## CASE STUDY

# AUTOMATIC GATE AT PRIMARY SCHOOL STAFF CAR PARK

**Site Details:** Gates fitted at end of road / alley way leading to a small staff car park. Entrance is also used for deliveries etc. Gate Safe was asked by the Head Teacher to carry out an independent survey on the gate system as part of a school safety audit.

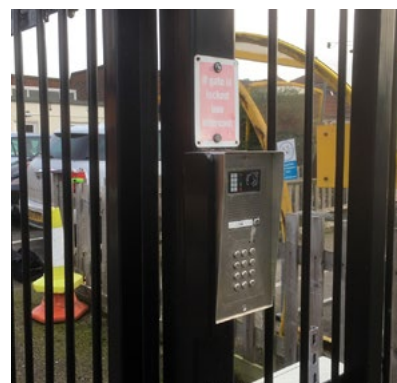
1. Risk of impact, trapping and crushing. Safety edges were only fitted horizontally to the bottom of the gate leaves on the inside of site. When tested, these edges only stopped the gates but did not revert. This represented a potential hazard since there was potential for a person to be pinned and trapped against the fence.

risk of gate crushing against a fence

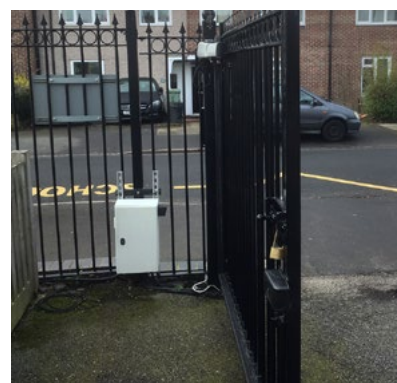
5. Risk of impact and crushing. No inside photocells were fitted to cover the arc of the gates.

gate features no inside photocells
